Re: Zoning Submission For Existing Lands At Cooleeny House, Cooleeny, Longford, Co. Longford Comprised Within Folio's LD4353 and LD10311 For Ardagh Demesne Limited

Part 8 Planning Application Submission
Proposed Road Improvement Works at Shroid, Cooleeny, Co. Longford
March 11th, 2020.

Document Control Sheet

Figure 3.1 – Site plan showing proposed new road layout (Source: Longford County Council)

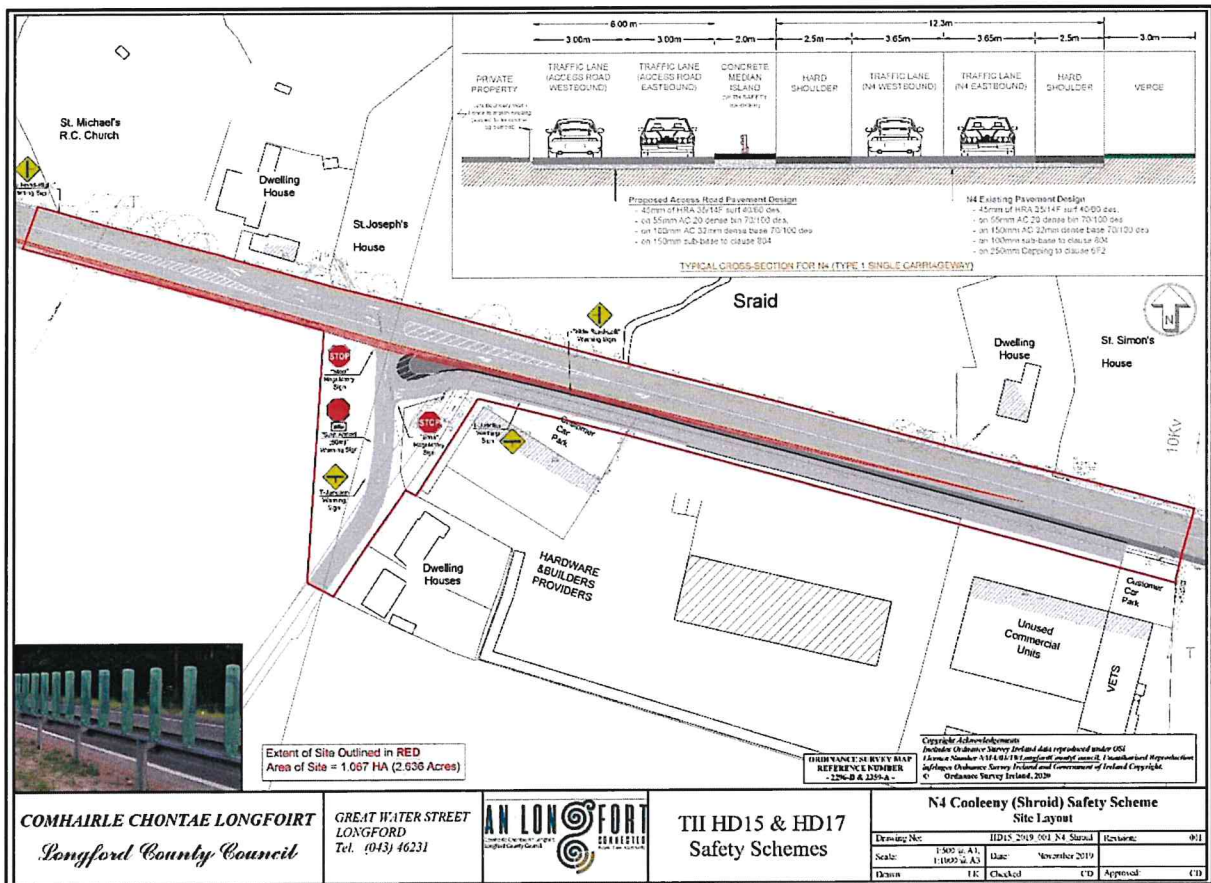
- The proposed new access road from local road L5167 to the existing businesses is located too close to the national road N4 and does not comply with TII Standard DN-GEO-03060: *“The provision of new priority junctions or direct accesses on minor roads shall not be permitted within 90m of a roundabout or priority junction on national roads; this may be reduced to 50m as a relaxation on Regional and Local roads.”*

- The revised junction layout between L5167 and N4 provides for a very tight bend for traffic turning off N4 and seeking to access the existing businesses. ORS are of the opinion that all vehicles, and HGV's in particular, will not be able to safely make the turn without straying across the median line of L5167 and/or having the rear section of the vehicle projecting onto the main carriageway of N4 while navigating the turn or waiting for clear space to complete the turn.

- ORS are of the opinion that the proximity of the new access on the L5167 and the N4 will give rise to a high risk of collision between vehicles turning off N4 and vehicles exiting the proposed access road to/from the existing businesses.

- In the proposed new layout, L5167 does not connect to N4 at a right angle, as is best practice, which may impede visibility and sightlines, particularly the view of traffic approaching from the east for traffic exiting L5167.

- The existing gate access into the field to the west which provides access to our client's lands off the L5167 will be removed to facilitate the proposed relocation of L5167-N4 junction. ORS notes that the submitted drawings do not indicate a new location for the field access gate.

Having considered the above, ORS propose that the design of the junction between L5167 and N4 should be revised to provide adequate sightlines at all junctions and to provide sufficient turning

room to allow all vehicles entering and exiting the junction to do so safely and in accordance with recommended road design criteria.

A suggested alternative layout is shown on the drawing in Appendix A. This layout will require a longer section of L5167 to be realigned and may also require additional lands to the west to be incorporated; however, this layout or similar will be a significant improvement in terms of road safety for road users on the N4 while protecting the existing road safety provided to users of L5167.
